DNR Project No. DC-0196

Subject: Dane County WQM Plan City of Madison (CUSA) - CARPC #1801EC, DNR DC-0196

Re: Water Quality Management Letter for Environmental Corridor Amendment Request
#1801EC – CUSA - Madison

RE: Environmental corridor on 5404 Voges Road, City of Madison

C-1.1

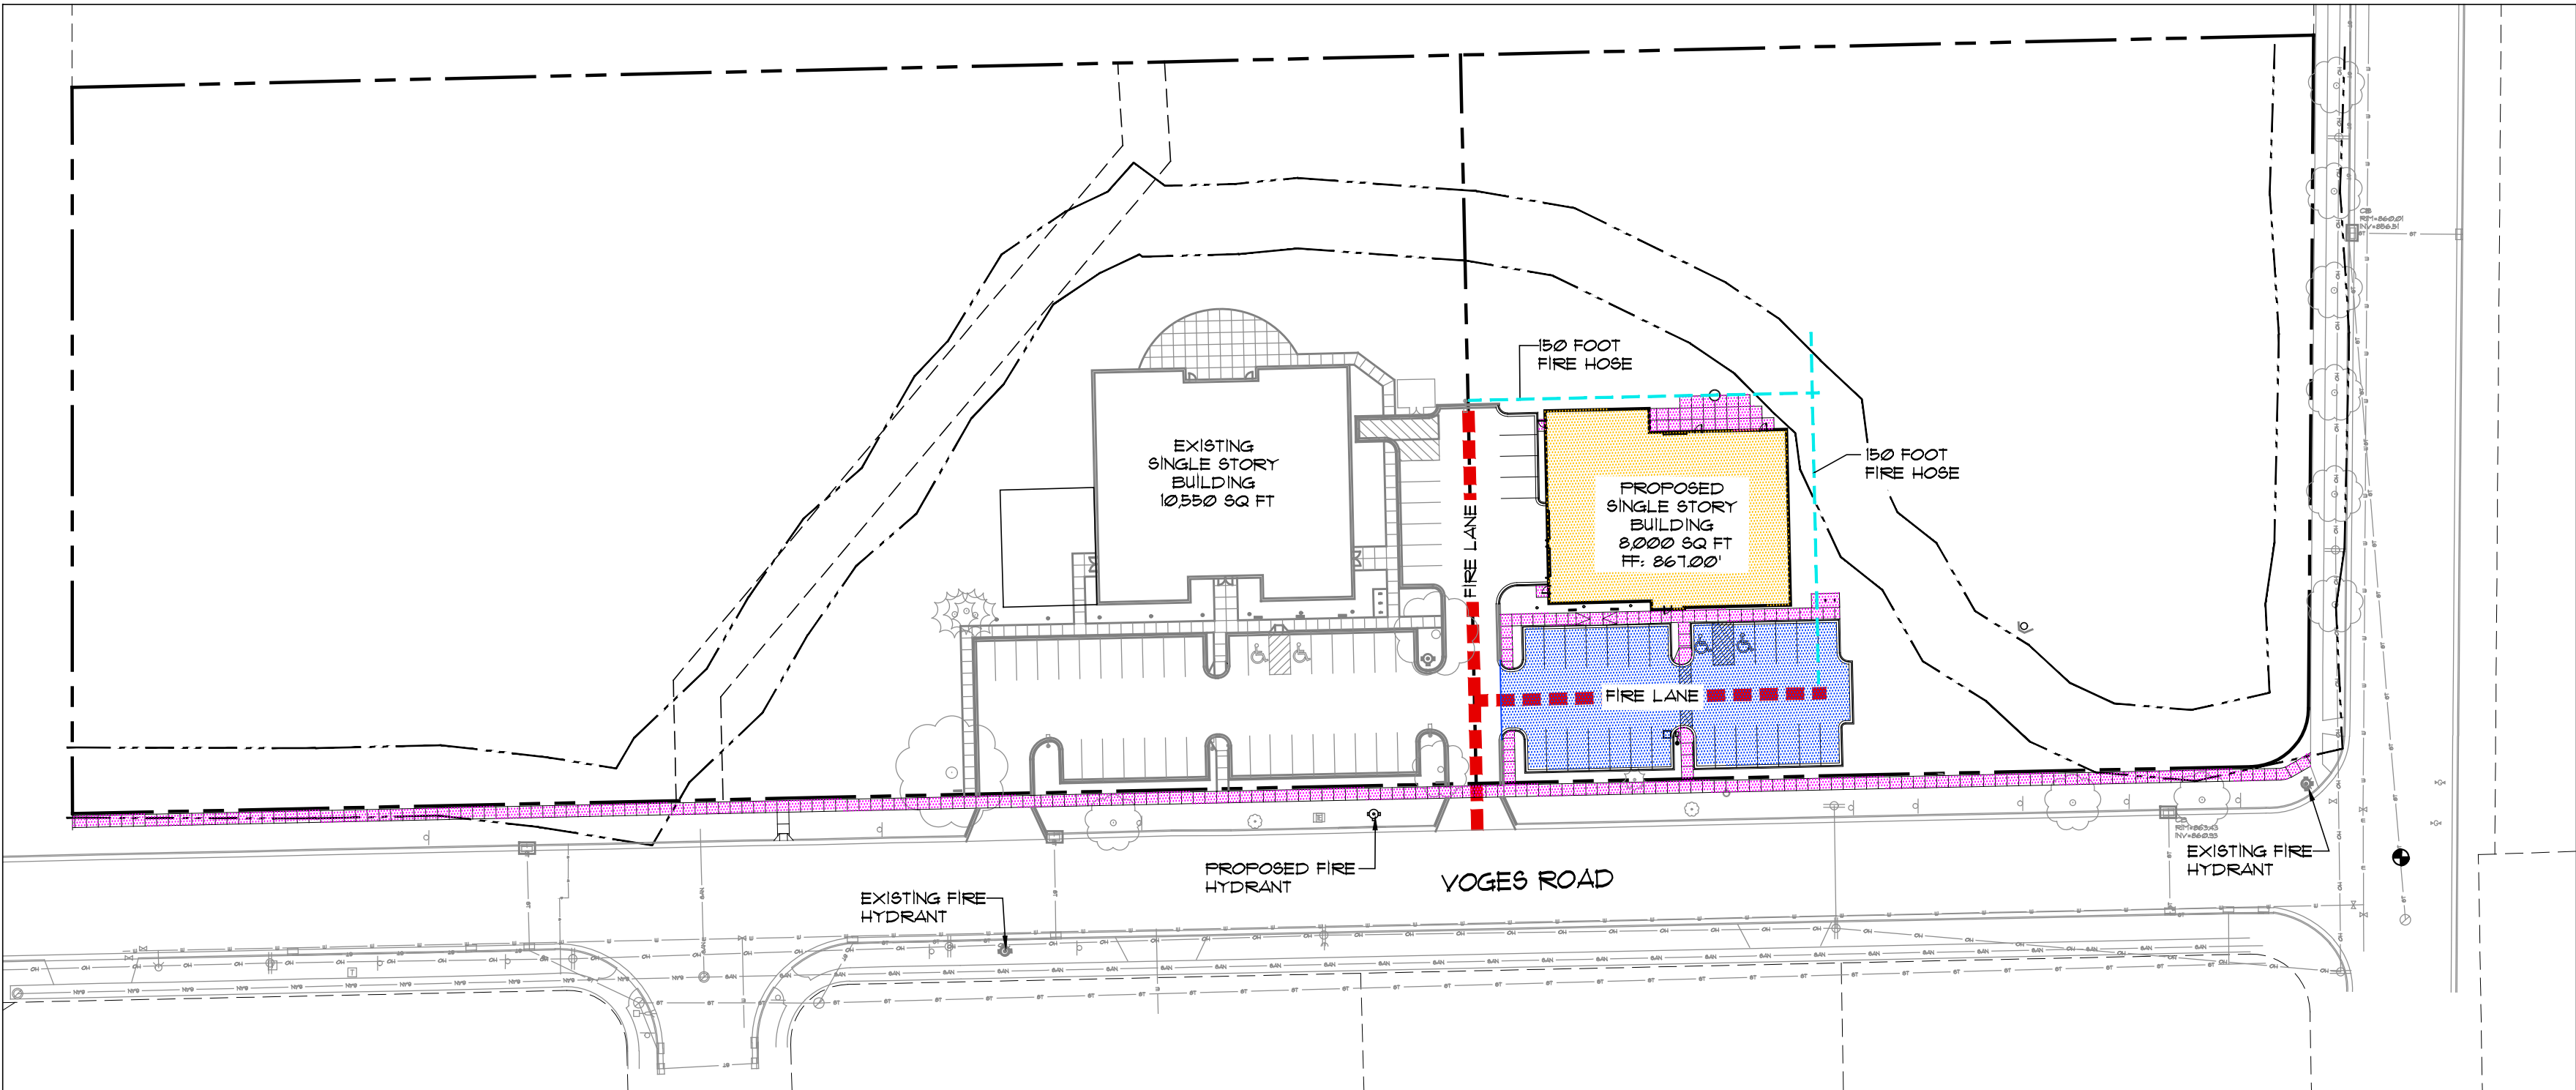
- Submit a revised site plan for CARPC review maintaining a minimum 75-foot parking lot setback from the delineated wetland edge in accordance with the City's application for this environmental corridor amendment.
- Require the provision of a level spreader or similar practice to spread the flow of water discharging toward the wetland.
- Require that the vegetated buffer be maintained in dense native vegetation at a height of at least 6 inches.

1. Submit a revised site plan for CARPC review maintaining a minimum 75-foot parking lot setback from the delineated wetland edge in accordance with the City's application for this environmental corridor amendment.
2. Require the provision of a level spreader or similar practice to spread the flow of water discharging toward the wetland.
3. Require that the vegetated buffer be maintained in dense native vegetation at a height of at least 6 inches.
4. Require a restoration and native vegetation management plan for the wetland buffer be recorded as part of the stormwater management maintenance agreement.
5. Consider requiring/encouraging the use of permeable pavement for the north patio and parking surfaces, where slopes are appropriate.
